### List of Requested Information

Sioux Energy Center (8501 MO-94, West Alton, Missouri)  
Meramec Energy Center (8200 Fine Road, St. Louis, Missouri)  
Labadie Energy Center (226 Labadie Power Plant Road, Labadie, Missouri)  
Rush Island Energy Center (100 Big Hollow Road, Festus, Missouri)

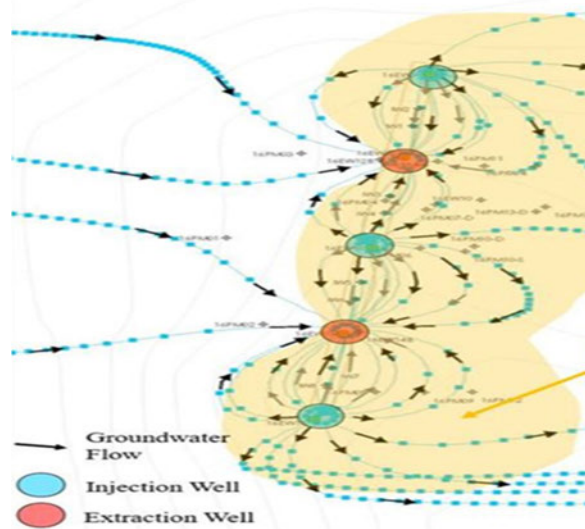
2. EPA has reviewed the CCR Rule compliance documents posted on Ameren's publicly available webpage for the Rush Island facility. Please provide the information set forth below.
  - a. EPA has reviewed Ameren's 2022 Annual Groundwater Monitoring and Corrective Action Report for the Rush Island facility. On page ES-3, Ameren states that the pilot study has been completed and that the pump and treat technology has been expanded to the entire downgradient side of the RCPA and it became fully operational in 2022. Based on the information in that report, EPA is requesting:
    - i. Information that indicates the capture zone of the extraction wells.

The capture zone is based on annual flow conditions across the Rush Island Energy Center ash basin of 34 ft/year as documented in the 2018 Annual Groundwater Monitoring and Corrective Action Report. This represents an average historical movement of a transport particle across the basin in an east/southeast direction over a given calendar year. It accounts for overall vector movement of that particle during normal, stagnant, flood and low-level river stages throughout that calendar year. A combination of both extraction and injection wells to capture and control that movement is used to ensure a net-zero difference in overall groundwater flow conditions. Essentially, what is removed for treatment is re-introduced in the same area so that outside the small corridor of capture and injection there is no change in overall flow conditions. The design accounts for treating the volume of water within the effective porosity of that control area, which is 34 feet wide by 70 feet of water column by 800 linear feet per building. To be conservative, a 45-foot width and 32% effective porosity were used to calculate 6,000,000 gallons of water per building per year for annual control. The well spacing and offset of the extraction well row and injection well row were modeled to reach a point of intermixing with 2-3 years. This resulted in 8 extraction wells and 8 injection wells in individual rows separated by 18 feet spaced 120 feet between wells on a 60-foot offset so that injection wells were approximately 60 feet from extraction wells. At 8 extraction wells per building with a 90% run time, the extraction rate per well equates to approximately 1.5 gpm.

The figure to the right illustrates how injection and extraction well integrate to form a linear control wall.

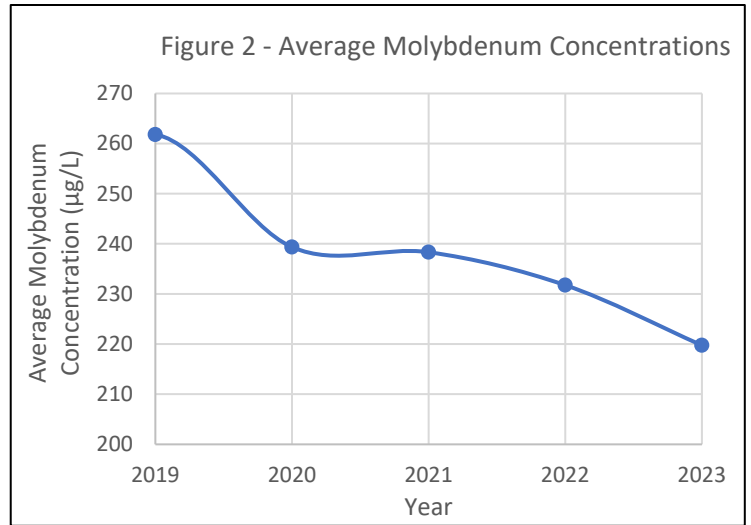
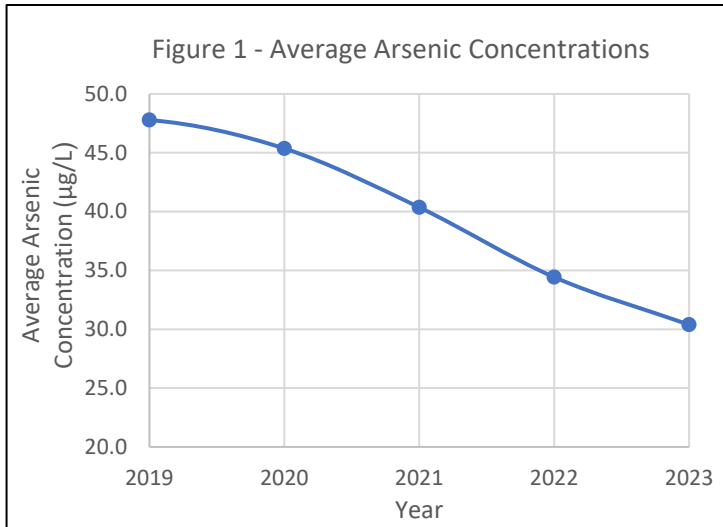
- d. A summary of the volume/amount of released Appendix IV constituents at statistically significant levels. Provide any plume map figures that define the nature and extent of the SSL releases.

*Arsenic and molybdenum at the Rush Island Energy Center (RIEC) have been detected at a Statistically Significant Level (SSL) over their respective site-specific Groundwater Protection Standards (GWPS). These constituents at SSLs were first determined in 2018 and more information on the semiannual SSL statistical evaluations is provided in the Annual Groundwater Monitoring and Corrective Action Reports.*

*As discussed in the 2023 Annual Groundwater Monitoring and Corrective Action Report, average concentrations of arsenic in monitoring wells downgradient of the RCPA have decreased approximately 36% since commencing closure of the RCPA in 2019 (See Figure 1 below). Additionally, since 2019, average concentrations of molybdenum in monitoring wells downgradient of the RCPA have decreased approximately 16% (See Figure 2 below).*

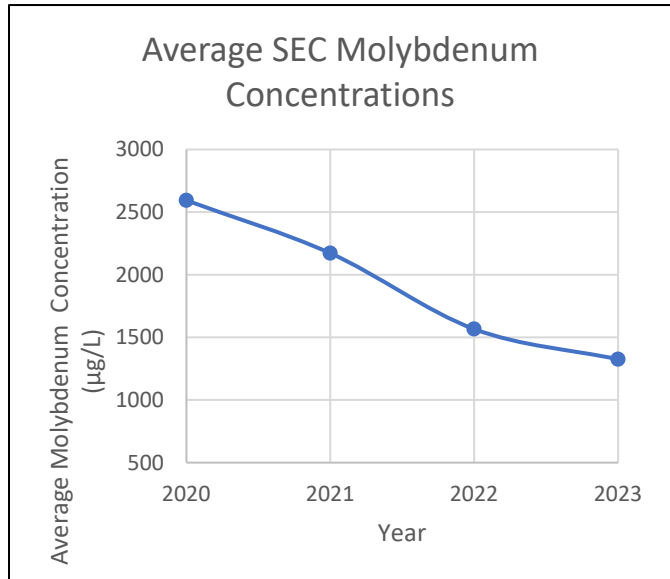
- g. A summary of the volume/amount of released Appendix IV constituents at statistically significant levels. Provide any plume map figures that define the nature

and extent of the SSL releases.

*Molybdenum is the only constituent at the Sioux Energy Center (SEC) that is present at a Statistically Significant Level (SSL) over the site-specific Groundwater Protection Standard (GWPS). This exceedance was determined in 2018. Additional information regarding the SSL statistical evaluations is provided in the Annual Groundwater Monitoring and Corrective Action Reports.*

*As discussed in the 2023 Annual Groundwater Monitoring and Corrective Action Report, average concentrations of molybdenum in monitoring wells adjacent to the SCPA have decreased approximately 49% since commencing closure of the SCPA in 2020 (See Figure).*

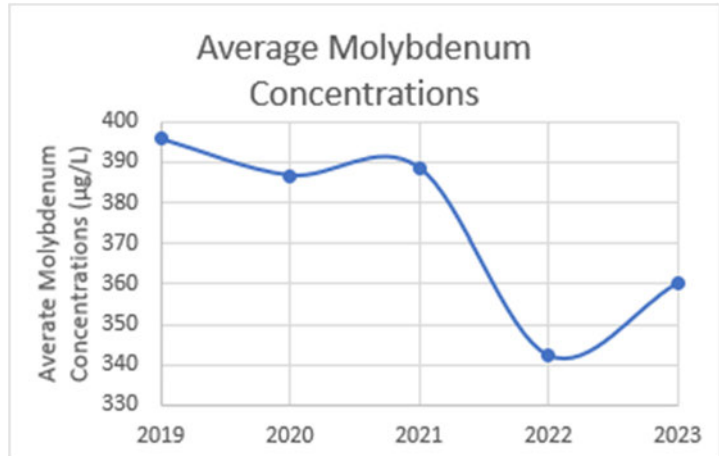
- e. A summary of the volume/amount of released Appendix IV constituents at statistically significant levels. Provide any plume map figures that define the nature and extent of the SSL releases.

*Molybdenum is the only constituent at the Labadie Energy Center (LEC) that is present at a Statistically Significant Level (SSL) over the site-specific Groundwater Protection Standard (GWPS). This was determined in 2018 and more information on the SSL statistical evaluations is provided in the Annual Groundwater Monitoring and Corrective Action Reports.*

As discussed in the 2023 Annual Groundwater Monitoring and Corrective Action Report, average concentrations of molybdenum in monitoring wells downgradient of the LCPA have decreased approximately 9% since commencing closure of the LCPA in 2019 (See Figure).
